ADDENDUM – 02

MOT BUILDING for FAIRFAX SCHOOL DISTRICT

ARCHITECT'S PROJECT NUMBER: #2023-2314

June 25, 2025 Architect's Project No: #2023-2314

Item II.01 Sheet E-100, "Site Electrical Plan," ∆3, dated 06/24/2025

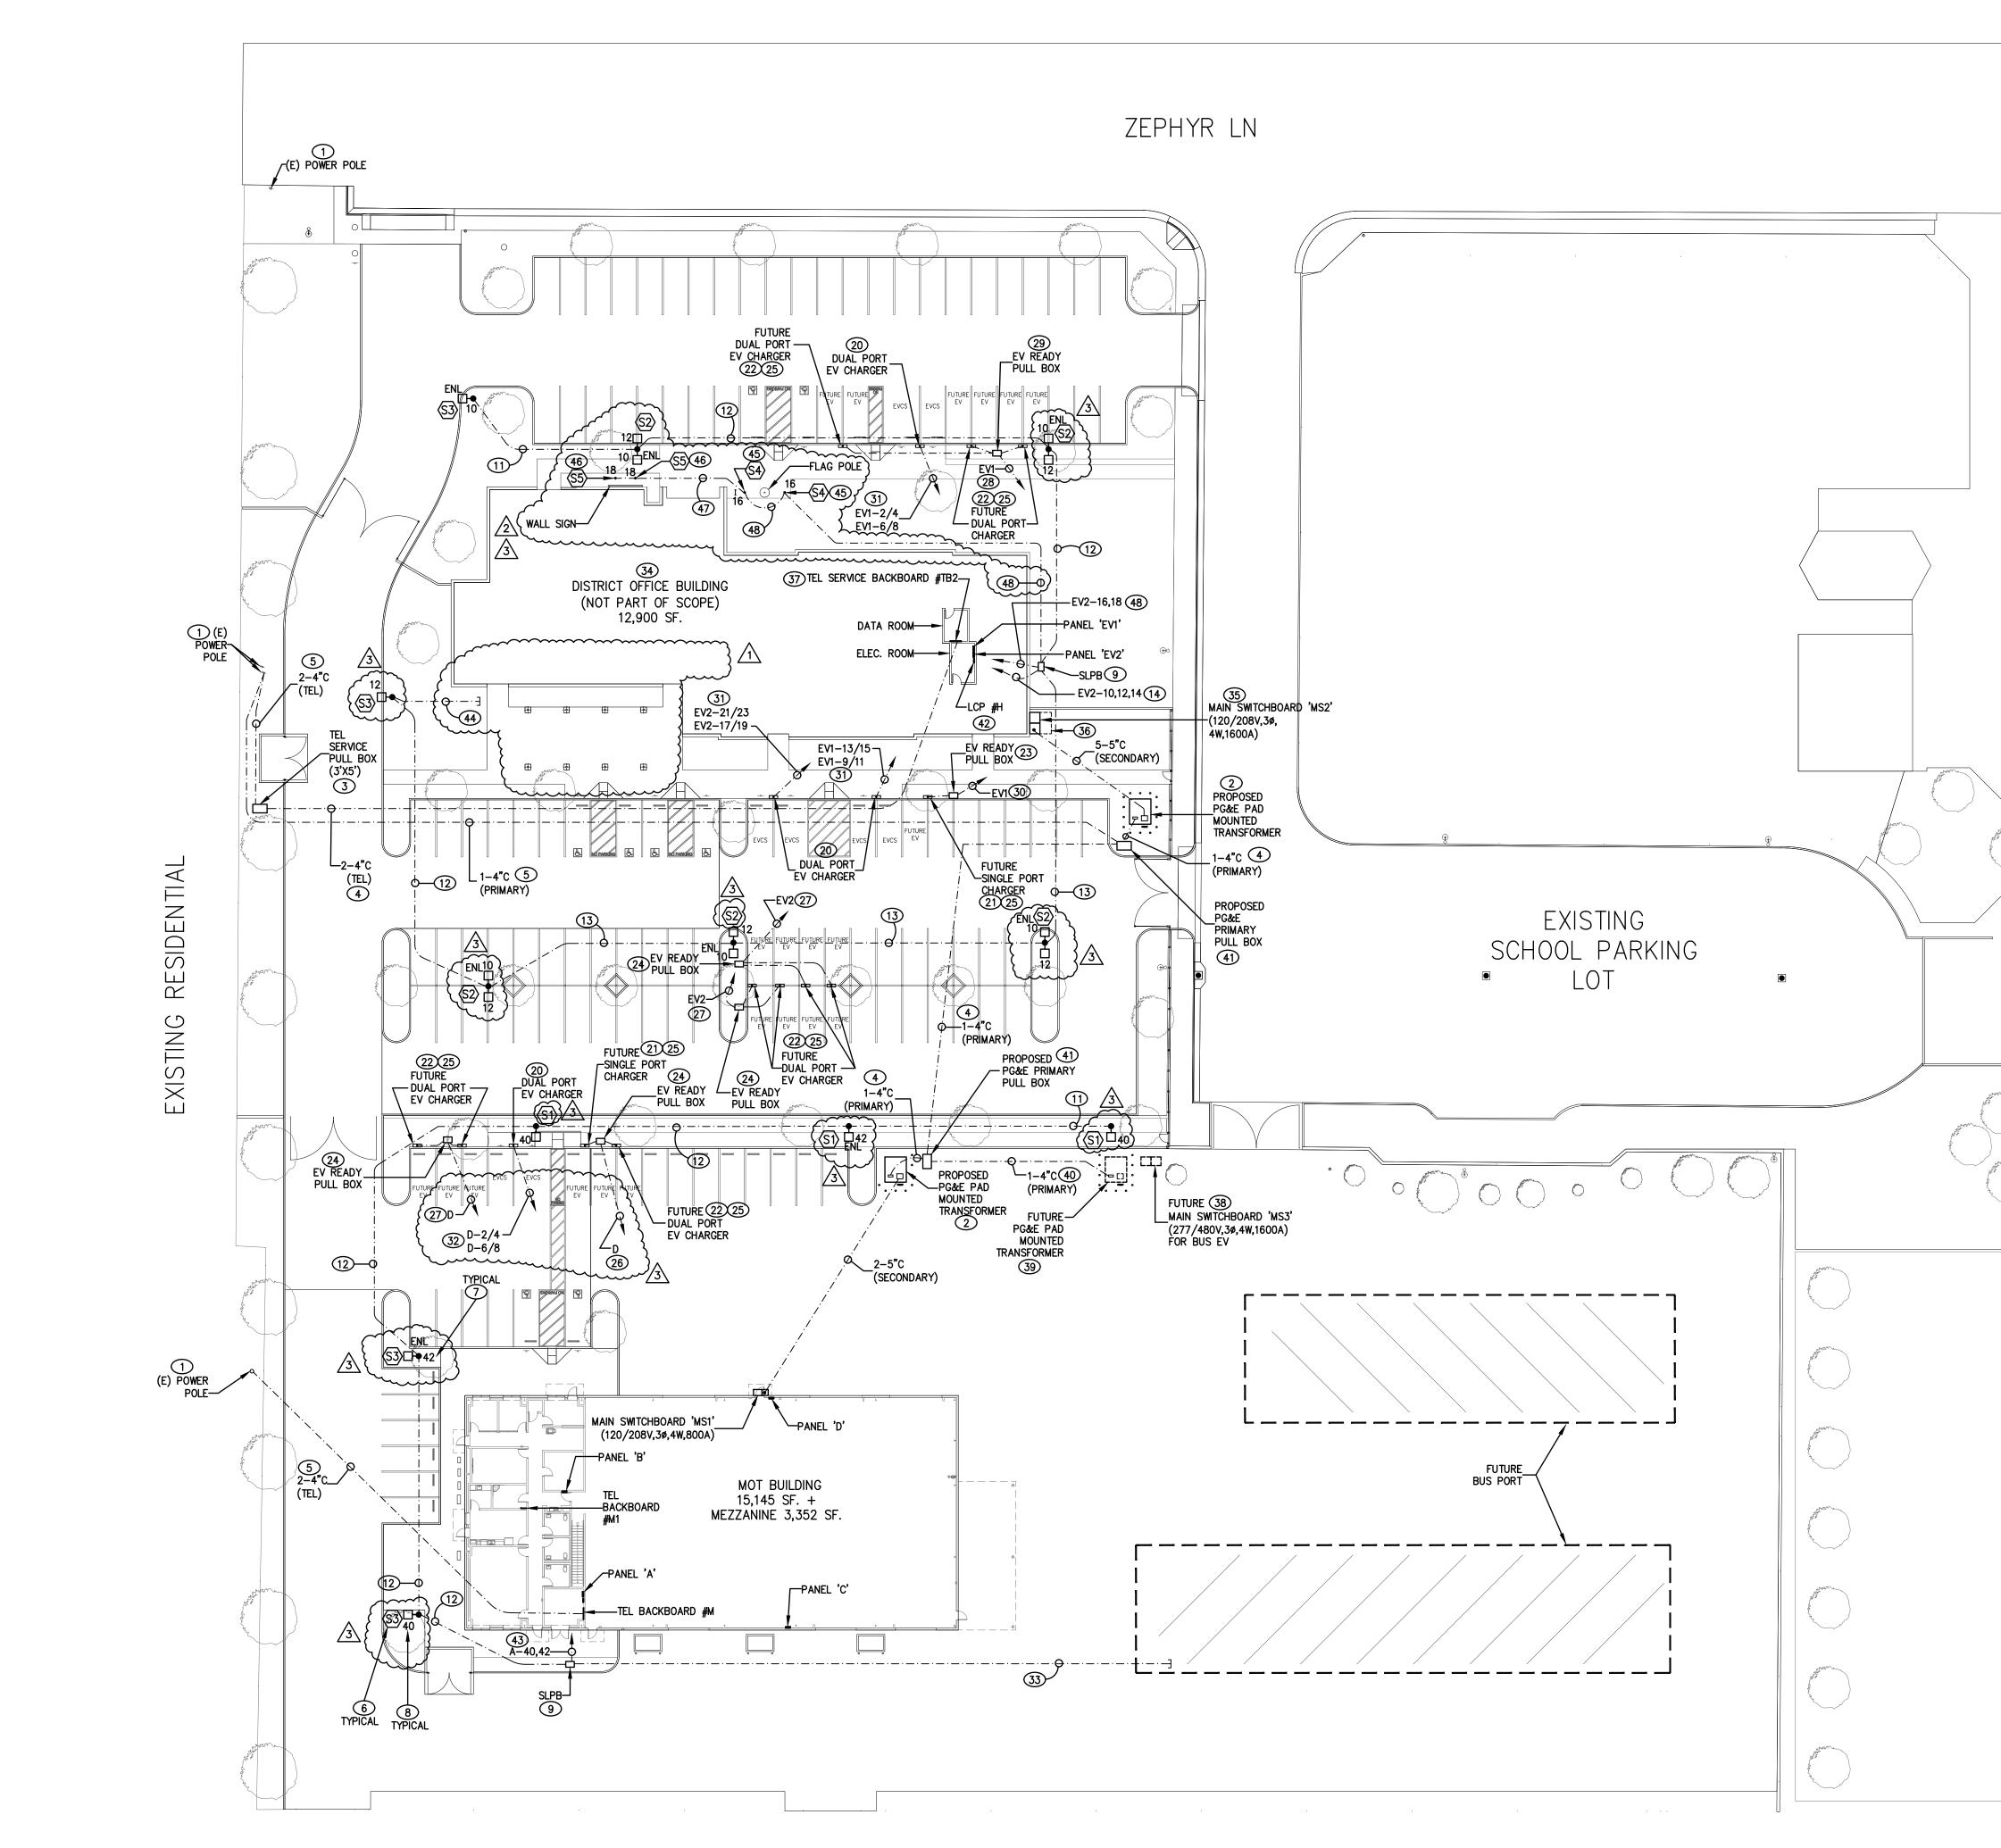
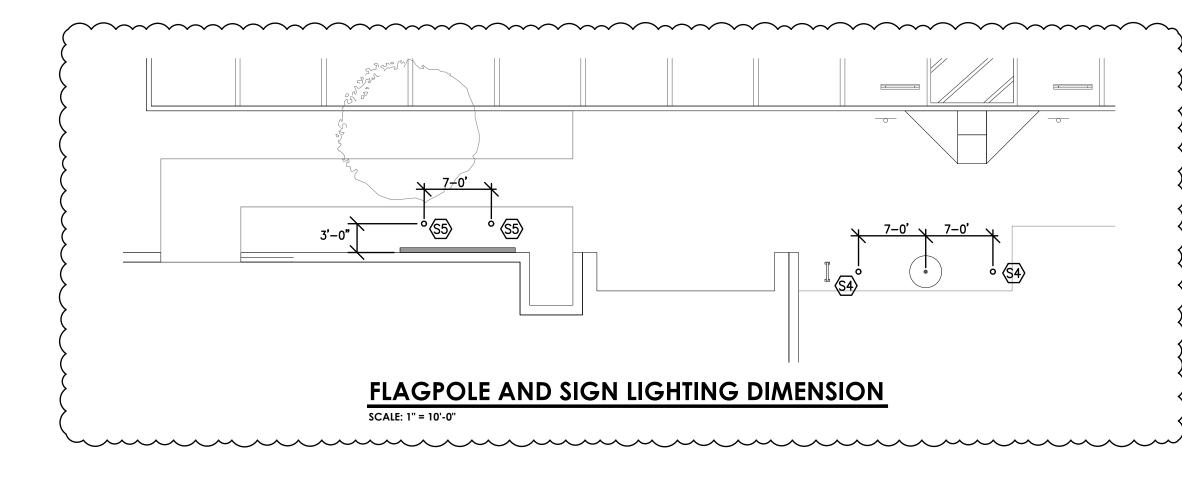
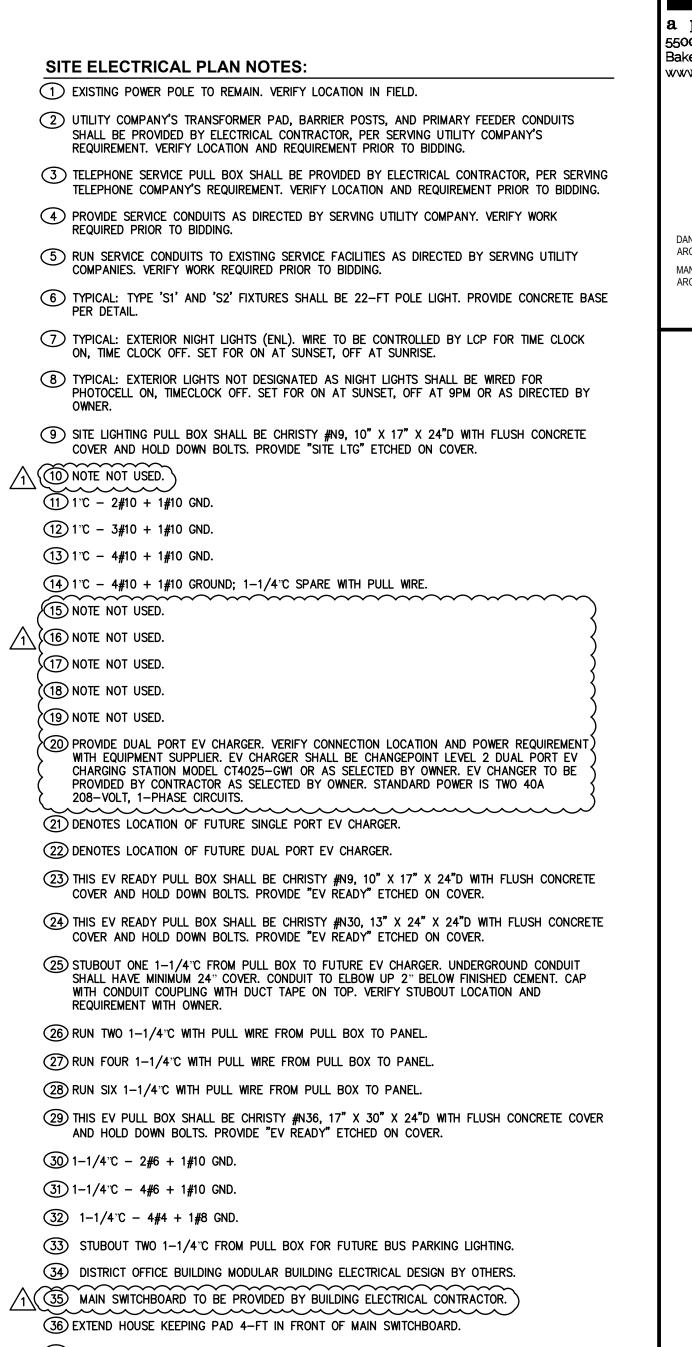
- A. Site electrical plan is incorrectly showing conduits to Panel 'EV3'. Revise to run conduits to Panel 'D' per attached plan.
- B. Pole light fixture identifications have been revised to match the plan symbol per attached plan.
